Burke-Gilman Trail Missing Link Project

Design Advisory Committee Meeting #4

July 27, 2017

Seattle
Department of
Transportation

Segment 1 – Input and Changes

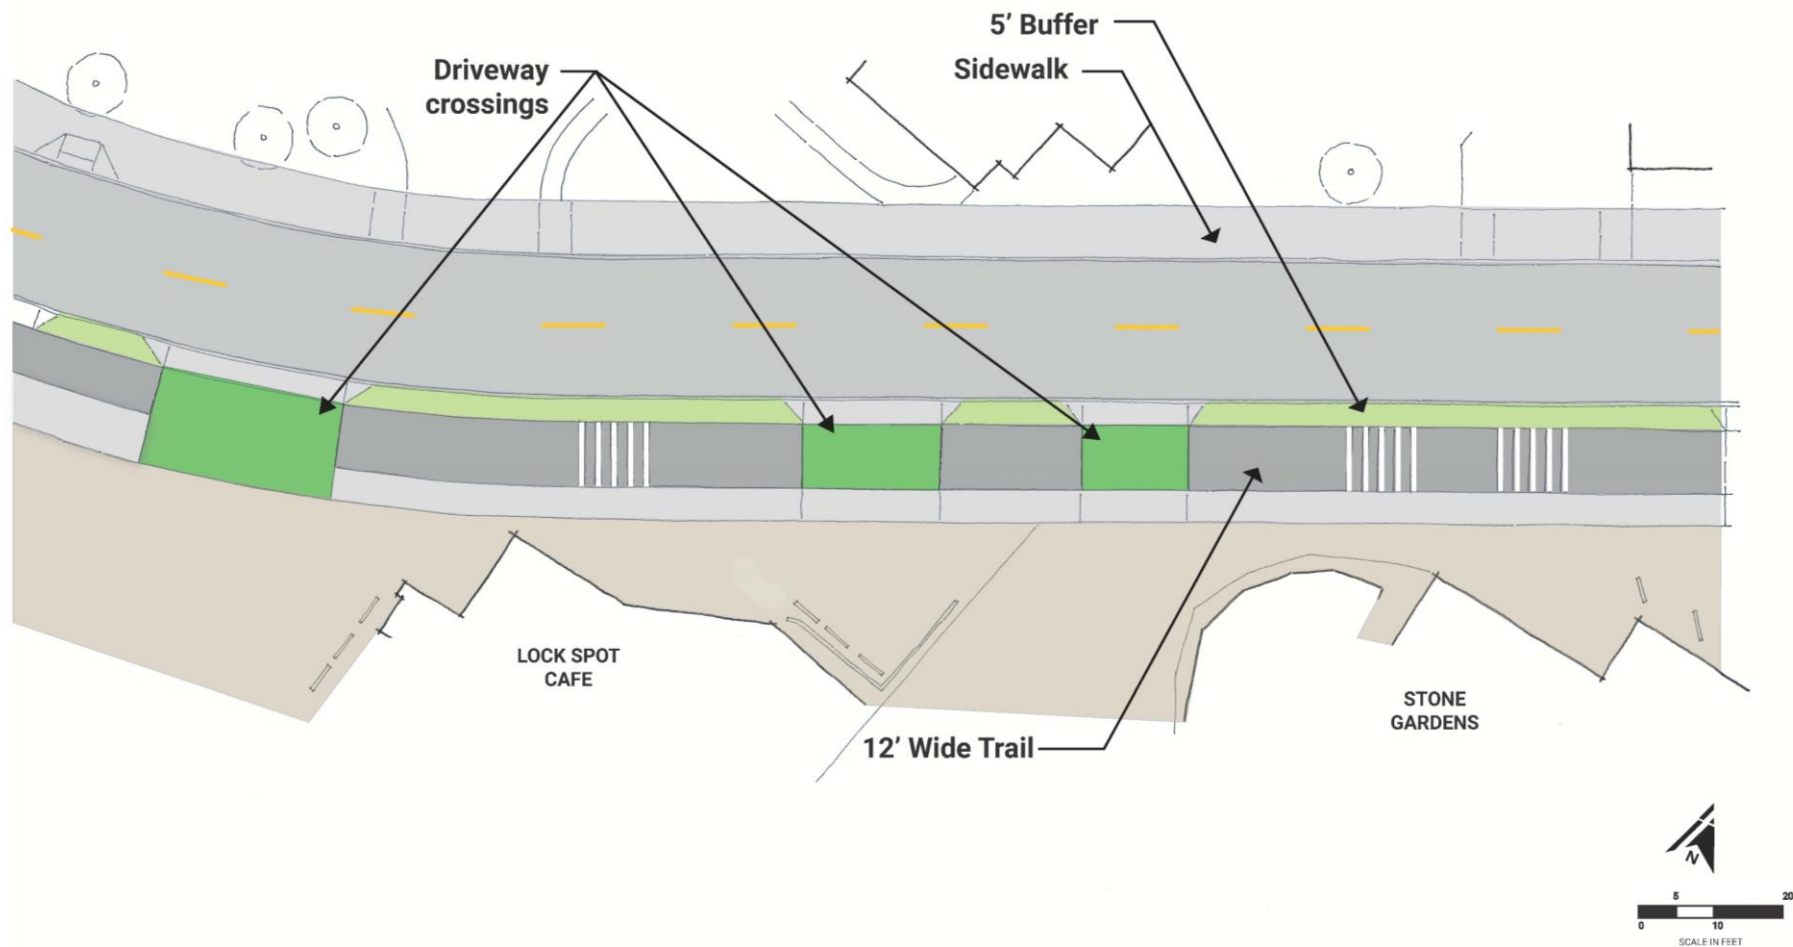
- **Maintain charter bus/metro layover parking spaces in front of the Locks**
 - This was shown as being removed in the FEIS design, but has been maintained in the 30% design.
- **Maintain 10' wide parking lane on north side of Market between 54th and 28th for Metro bus layover**
 - FEIS design had 8' parking lane, 30% design includes 10' parking lane.
- **Add westbound left turn lane at Market/28th with protected signal phase**
 - Included in 30% design
- **Coordinate design/construction with the Nordic Heritage Museum (NHM)**
 - Weekly meetings with the Nordic since June 2017, interim and final conditions included in the Nordic SIP and 30% BGT design
- **Use concrete instead of asphalt for Market St trail**
 - Included in 30% design, internal discussion ongoing

Segment 2 – Input and Changes

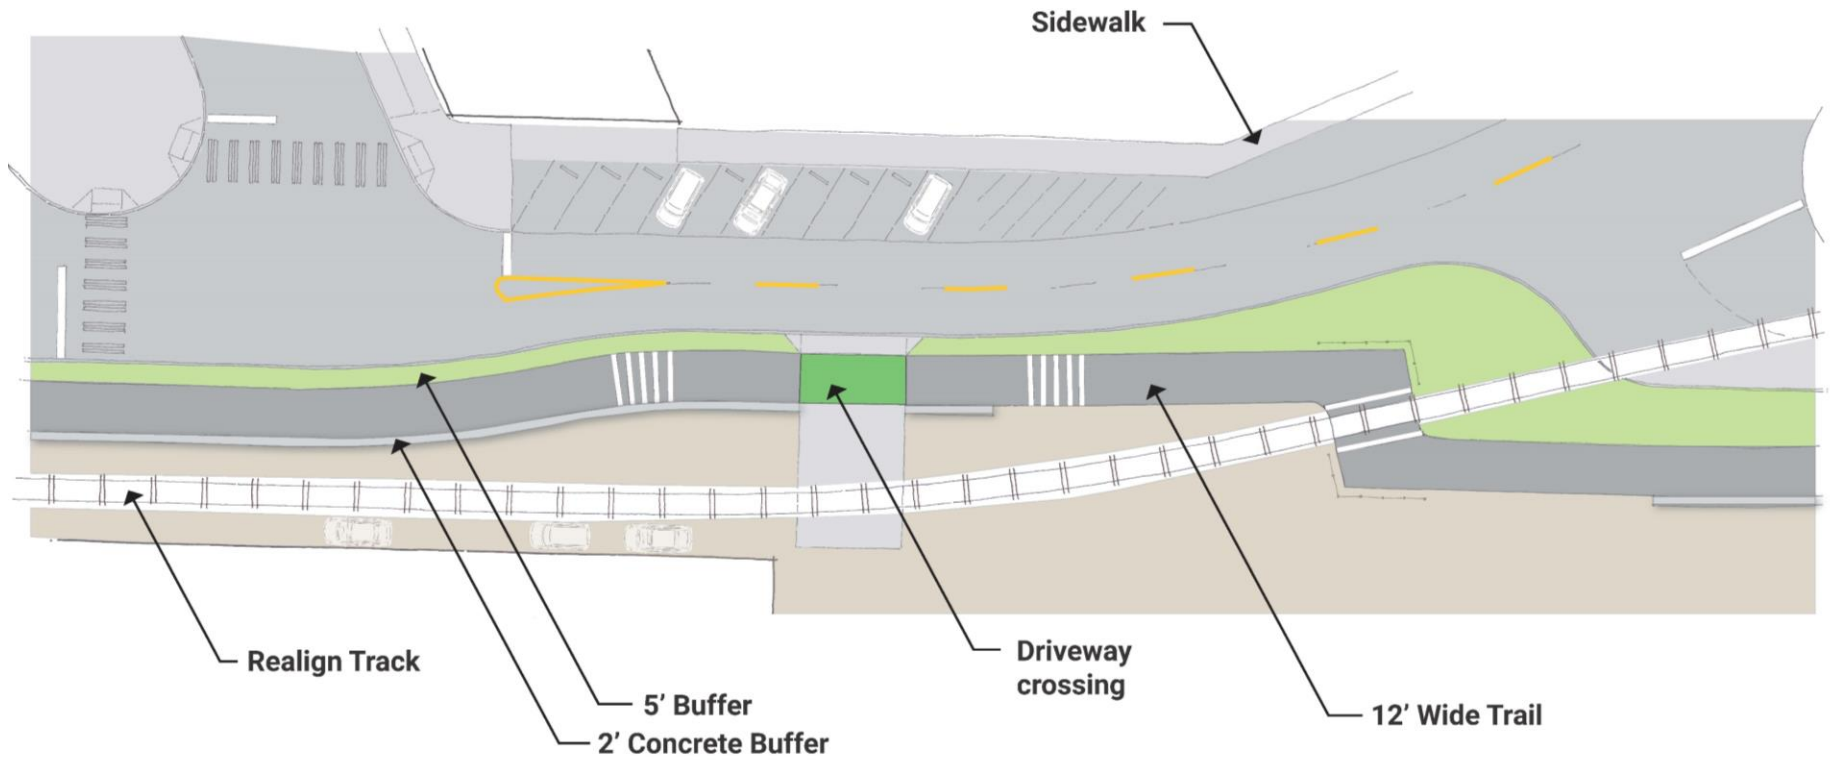
- **Improve safety at Shilshole/24th**
 - 30% design includes an option to close 24th and build a new roadway along the rail line (“54th extension”). Still studying WB67 movements or reroutes.
- **Improve rail crossing for bicyclists**
 - Added fencing and widened trail at the crossing
- **Maintain staging and parking space**
 - 20’ – 30’ of ROW will be unused and unregulated on the south side of Shilshole between approximately Vernon and 46th. This space can continue to be used for staging, loading, and/or parking.
- **Avoid drainage impacts to property owners**
 - Trail will drain toward the street and runoff will be captured in SPU managed storm drains.

Segment 3 – Input and Changes

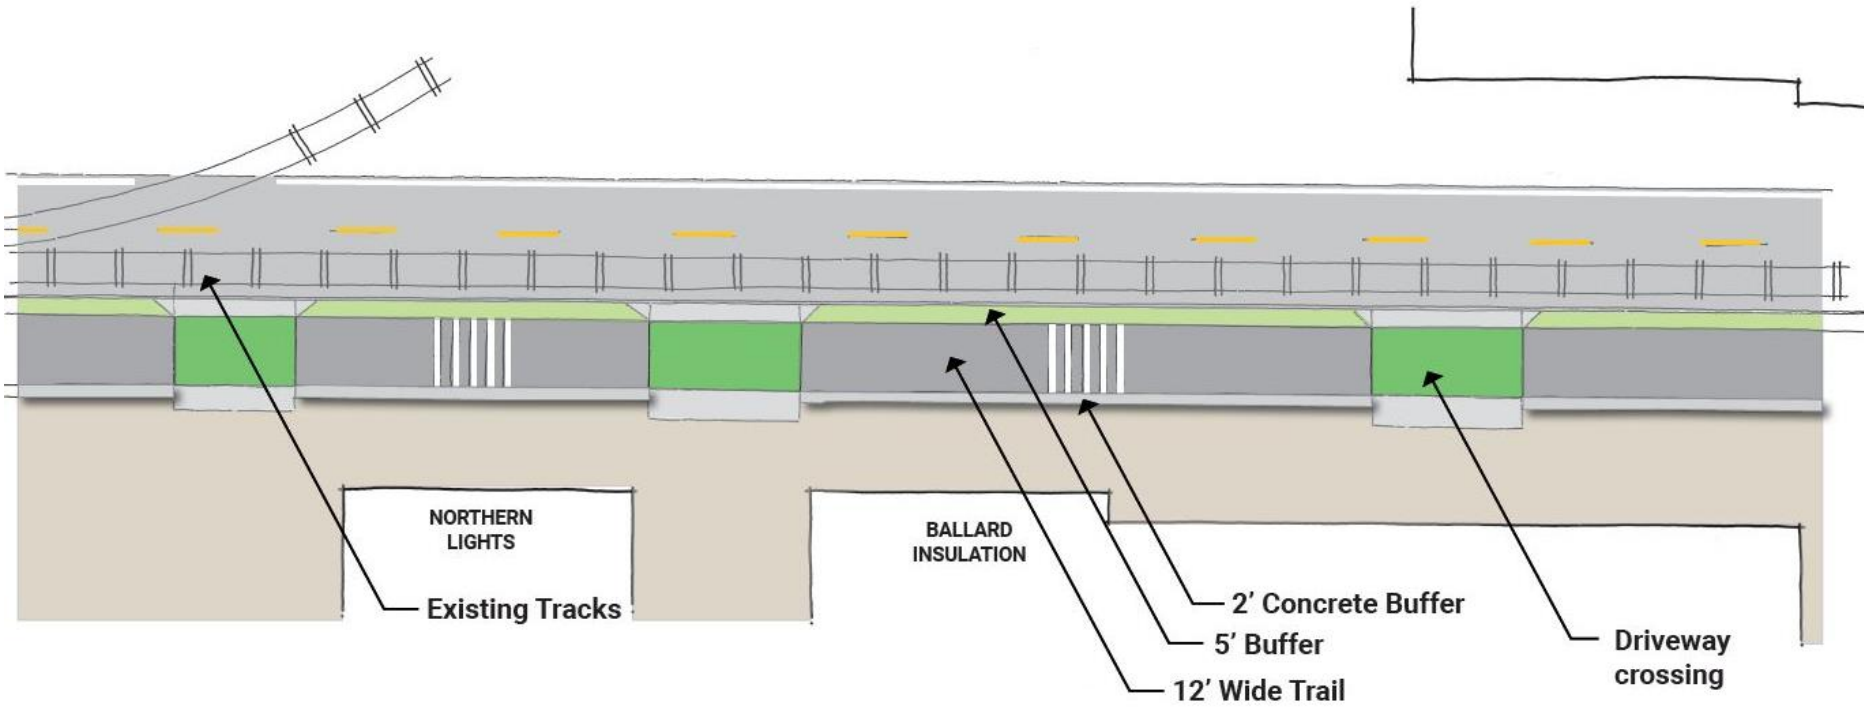
- **Increase lane width on 45th to 11 feet** to accommodate larger trucks
 - All lanes shown as 11 feet wide in the 30% design
- **Retain loading access for properties on the south side of NW 45th between 11th-14th**
 - Locking docks and access points are not impacted in 30% design. Route and movement of trucks entering / exiting loading dock to be discussed further during 60% design.
- **Maintain 4-way stop at 45th/11th**
 - Maintained in 30% design
